Madoka Assistant App Update to version 1.13.0

April 2022

1. Firmware update for EKVDX-A compatibility.

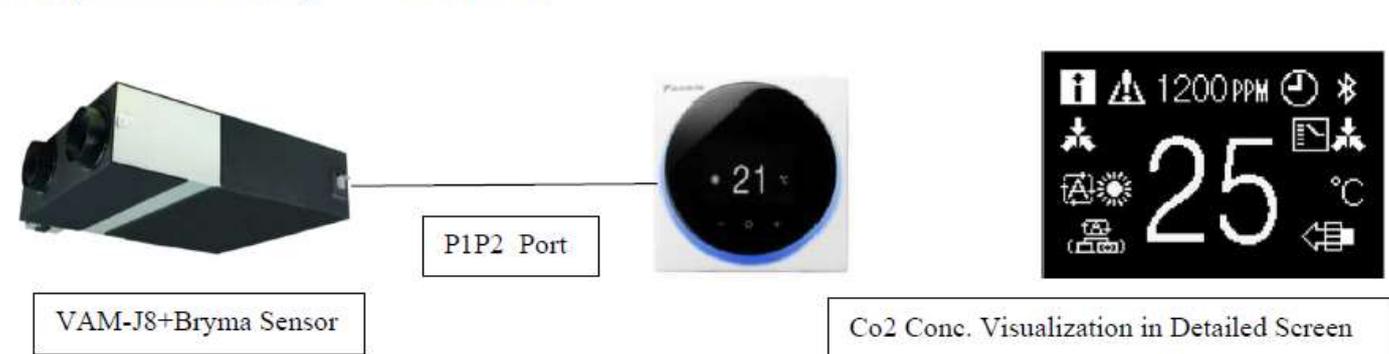
The existing BRC1H52* Madoka remote controller cannot control a VAM-DX module with a R32 DX coil attached, hence a firmware update to V1.06 will be required to enable communication between the VAM-J8 and the DX Unit (EKVDX-A).

1. Madoka remote controller connected to VAM DX module must have firmware updated to V1.06.
2. Madoka remote controller connected to 'normal' DX fan coil unit does not require the update.
3. Every VAM-DX unit module requires it's own BRC1H remote controller. i.e. It is not possible to 'loop' P1/P2 from several VAM+EKVDXs or VAM+EKVDX & other indoor unit to 1 remote controller.

When connecting to the Madoka remote controller via the Madoka Assistant App, you will be prompted to upgrade the firmware to the latest version.

During unit commissioning, if the firmware update has not performed, the below errors will be indicated.

- UJ-35: No communication with VAM-J8 Unit.
- UJ-36: No correct setting.

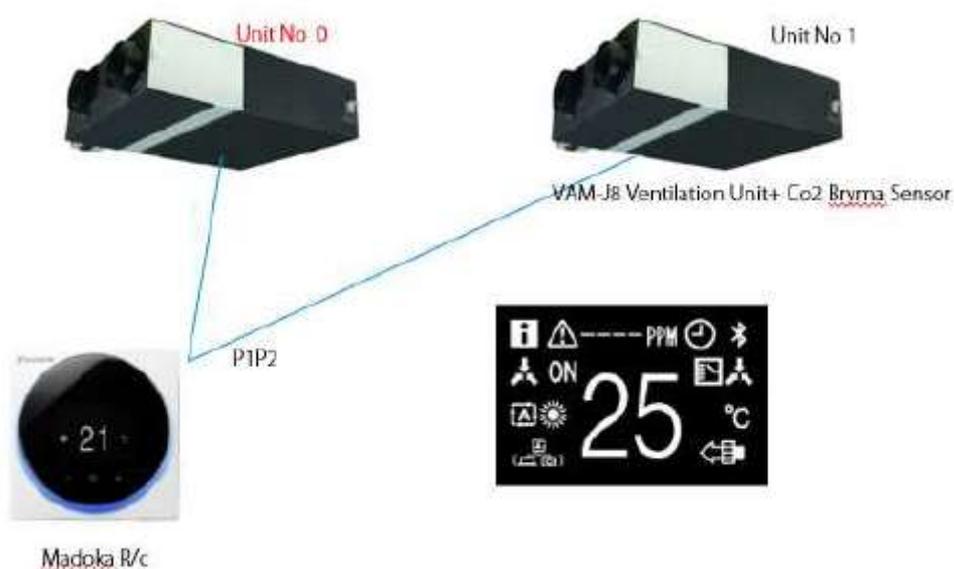
Situation 2: What to do when Co2 concentration is shown as a blank - as shown below?

Answer: It is possible that the lowest unit number does not have a BRYMA Sensor connected. To solve this change the unit number via Madoka Assistant.

3. Forcing of Madoka controller to flash the status LED when connecting to App.

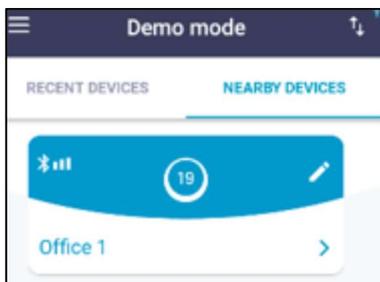
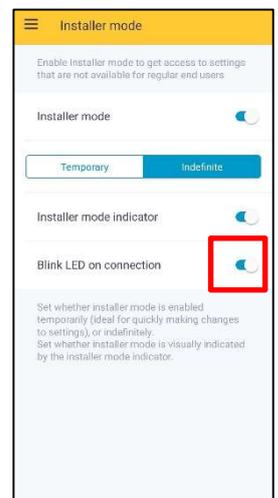
It can often be difficult to identify which Madoka is which during commissioning. To improve the identification when multiple Madokas are located close to each other a visual identification has been added. The Daikin Eye will flash for 10-15 second when a connection is attempted with the Madoka Assistant App.

To enable this function, enter the Installer selection screen in the App. Via a slider you will be able to enable or disable this function.

When selecting the Madoka controller from the list presented within the App, the Blue status LED will flash.
